NIAGARA MOHAWK POWER CORPORATION

DOCKET NO. 50-220

Proposed Changes to Technical Specifications (Appendix A)

Supporting Information and No Significant Hazards Considerations Analysis

FIGURE 3.2.2.a

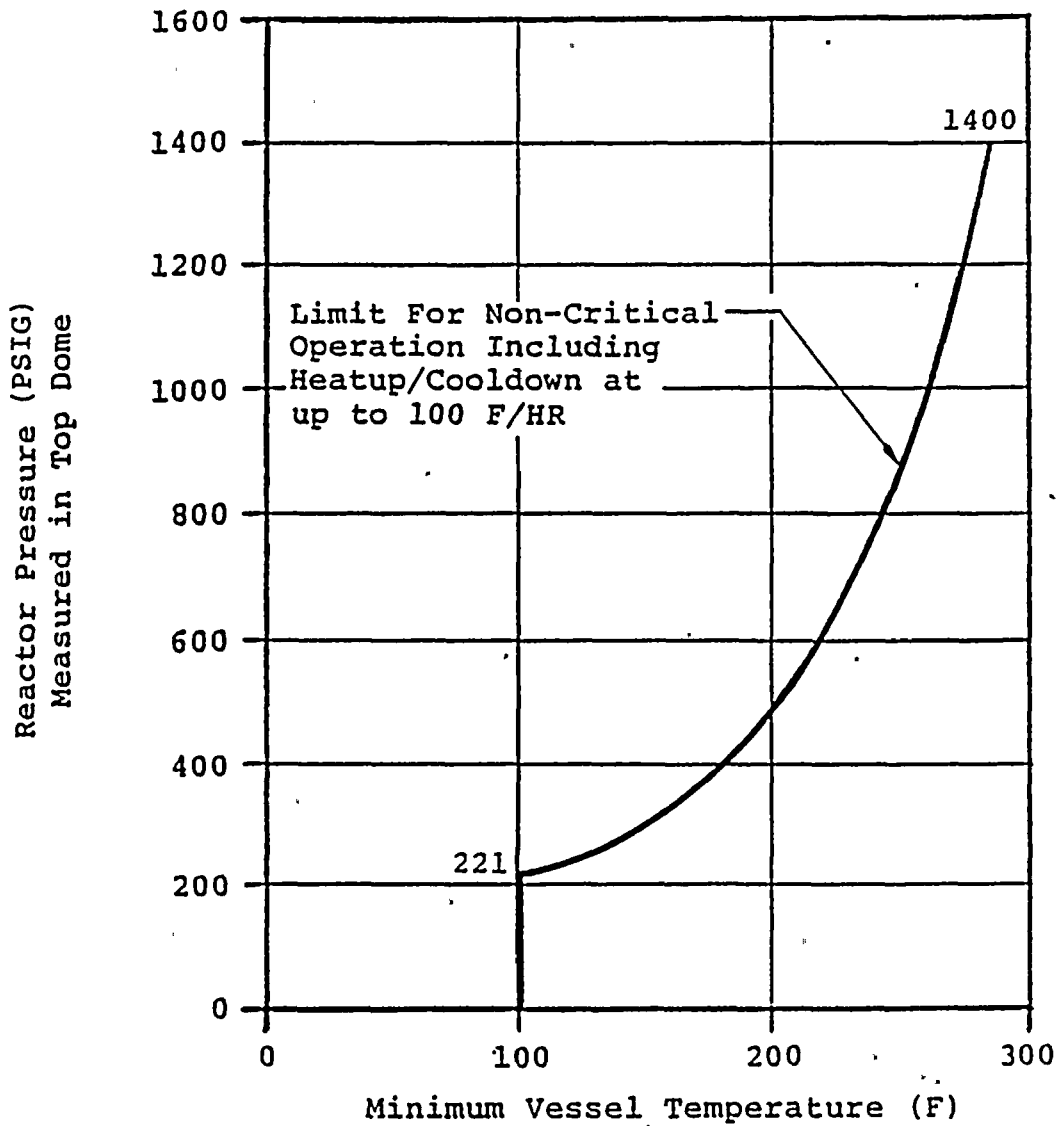
The proposed revision to Figures 3.2.2a, b and c reflect a change in the limits for minimum reactor vessel temperature for pressurization. These limits are based on measured nil-ductility temperature shifts of irradiated vessel material samples.

Based on these tests, pressure/temperature operating limits (curves) appropriate for up to thirteen effective full power years were established. These pressure/temperature curves were developed at the same time as the pressure/temperature curves for eleven effective full power years which were approved by the NRC staff in Amendment No. 85 to License No. DPR-63 on June 10, 1986. Since that time, no new data has been obtained which would affect the pressure/temperature limits for thirteen effective full power years. The Regulatory Guide 1.99 (proposed Revision 2) method for extrapolation was used except for the recommended addition of one standard deviation to the nil-ductility temperature shift.

MINIMUM TEMPERATURE FOR PRESSURIZATION DURING HEATUP OR COOLDOWN (REACTOR NOT CRITICAL) (HEATING OR COOLING RATE  $\leq 100$  F/HR) FOR UP TO THIRTEEN EFFECTIVE FULL POWER YEARS OF CORE OPERATION
